**CANOE BROOK RESERVOIR  
NO. 3 DAM**

**3 PHASE I INSPECTION REPORT  
NATIONAL DAM SAFETY PROGRAM.**

NJ 00527  
NJ 00550

PHASE I REPORT  
NATIONAL DAM SAFETY PROGRAM

**PHOTO 1**

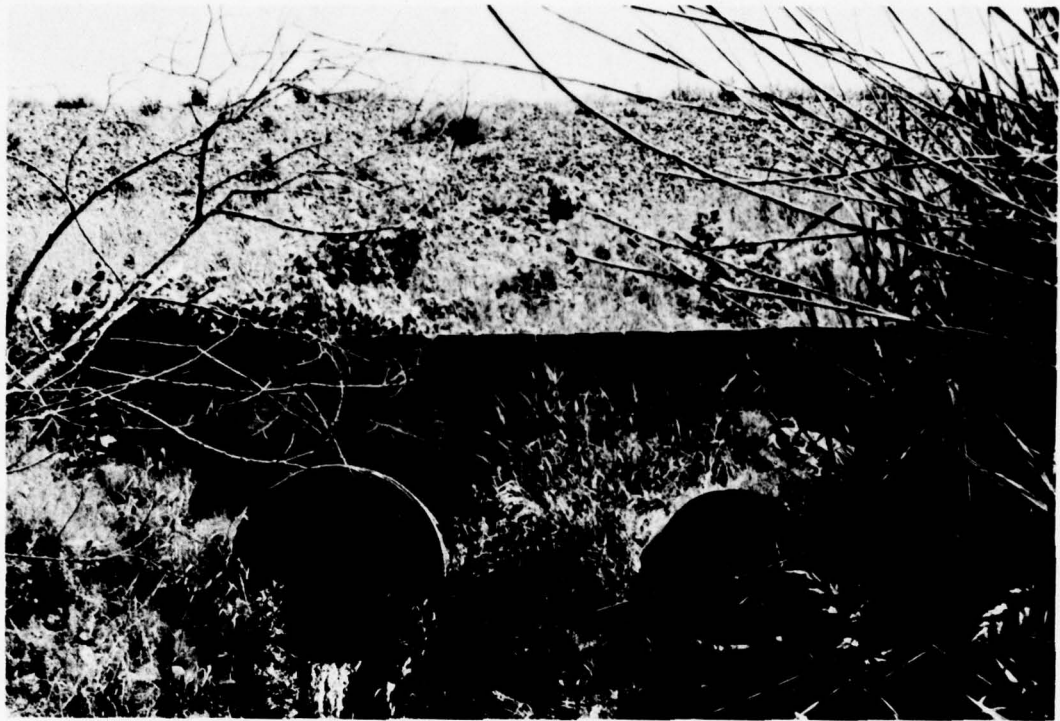
The 24 inch diameter relief well and reservoir outlet pipe discharging from the headwall at the downstream toe of the dam was functioning but it was about one-half full of sediment. No other deficiencies were observed in the visible section of this pipe.

A scour pit several feet in length and breadth and about two feet deep had developed in the stream channel immediately downstream from the headwall from which the above-mentioned 24 inch pipe and the 36 inch storm drain discharge. No deficiencies were observed in the visible section of the 36 inch pipe.

- Photo 1 - View Upstream (Southeast) at Dam Showing Center of Downstream Slope; Concrete Headwall has 36 Inch Storm Drain Outlet on Left, 24 Inch Outlet for Reservoir and Foundation Relief Wells on Right - 14 June 1978.

The scour pit located downstream from the headwall at the downstream toe is a relatively minor erosional problem which certainly does not endanger the structural stability of the dam. Riprap consisting of moderate to large size boulders should be placed in this scour pit to dissipate energy of the water discharged from the 36 inch drain pipe, thereby preventing additional scour.
